INDESIT company

Model type:
AVXD109EU

Commercial code:
F029621

1140960 Exploded views

n1040306: Reduction of cabinet depth on ARISTON EVOII 6kg washing machines produced at Bre

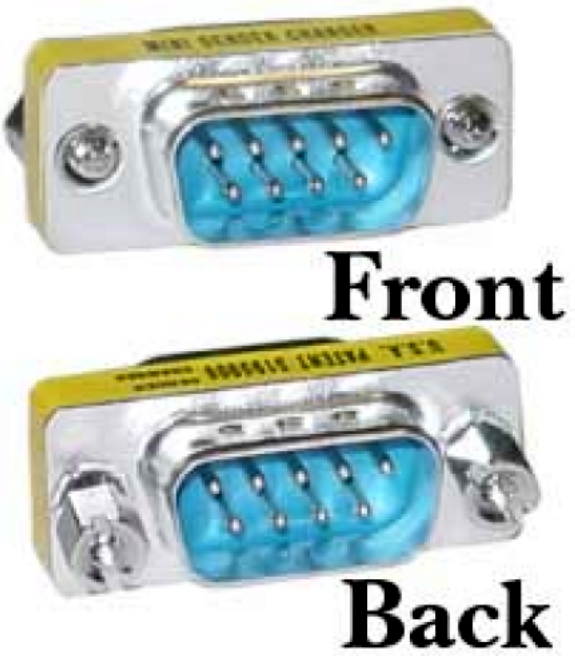
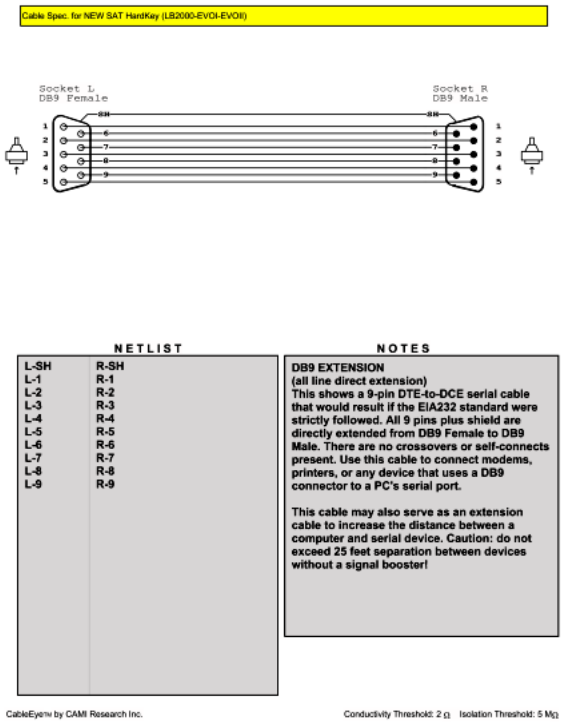
From serial no. 30915.0001, ARISTON EVOII 6kg washing machines affected by this note have been modified due to the reduced depth of the cabinet.
The modified models have a new industrial code.
The items affected by the modification are: cabinet, packing kit, top, product dispenser lid (including solenoid valve) and

solenoid valve.
Regarding the packaging kit, top, product dispenser lid and solenoid valve, the Replacements Warehouse will continue to manage premodification and new parts.
The premodification cabinets will be managed while stocks last, after which, in case of cabinet replacement the new cabinet, top and solenoid valve must be used, referring to the spare parts list for the relevant model.
Given below is a list of models affected by the modification with relevant new and premodification parts:

AVXD109EU (industrial codes: new 91296210001, premodification 91296210000);
AVXD129EX (industrial codes: new 91296220001, premodification 91296220000);
AVXL105EX (industrial codes: new 91296600001, premodification 91296600000);
AVXL109R (industrial codes: new 91297720001, premodification 91297720000);
AVXL89EU (industrial codes: new 91296230001, premodification 91296230000);
AVXD129EU (industrial codes: new 91284980101, premodification 1284980100);
AVXL109EU (industrial codes: new 91296240001, premodification 91296240000);
AVXD125FR (industrial codes: new 91284990101, premodification 91284990100);
AVXL100FR (industrial codes: new 91295430001, premodification 91295430000);
AVXL120FR (industrial codes: new 91295430001, premodification 91295430000);
AVXL88IT (industrial codes: new 91295180001, premodification 91295180000);
AVXL108IT (industrial codes: new 91284970101, premodification 91284970100);
Cabinet: premodification 095747, new 097709;

Packing kit: premodification 095741, new 094777;
Top: premodification 095738, new 097710;
Product dispenser lid (including solenoid valve): premodification 095740, new 097711;
Solenoid valve 1E2U: premodification 095739, new 097712.

AVXL105TK (industrial codes: new 91284830101, premodification 91284830100);
Cabinet: premodification 095747, new 097709;
Packing kit: premodification 095741, new 094777;
Top: premodification 095738, new 097710;
Product dispenser lid (including solenoid valve): premodification 096021, new 097715;
Solenoid valve 1E2U: premodification 095739, new 097712;
Solenoid valve 1E1U: premodification 096022, new 097716.

n1040381: Drain pump with bayonet-style filter - front Loading Brembate

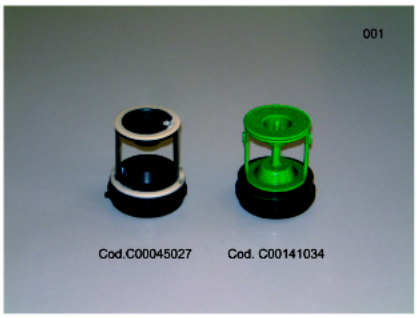
From serial no. 50720.0001 a new drain pump with bayonet-style filter has been installed on all front loading washing machines manufactured in Brembate.

New parts:
C00119307 - Drain pump
C00141034 - Pump filter kit

Premodification parts:
C00092264 - Drain pump
C00045027 - Pump filter kit

The new parts can be used instead of premodification ones.

n4008f00: Thermic link wire removed on three-phase motor

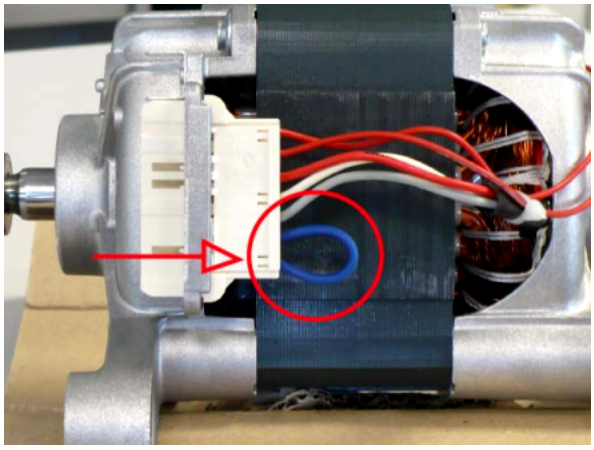
Attention!
When you assist the premodification models using the new motor code you MUST use the thermic link wire code C00265838.

In the attached image you can see the fixing of thermic link wire in the motor therminal box.

The spare part warehouses will manage the premodification motor until the end of the stock, after they will be replaced with new ones and thermic link wire.

TRIPHASE P40 46 L – PLASTIC TUB
C00265826 new motor without thermic link wire - C00142390 premodification motor with thermic link wire
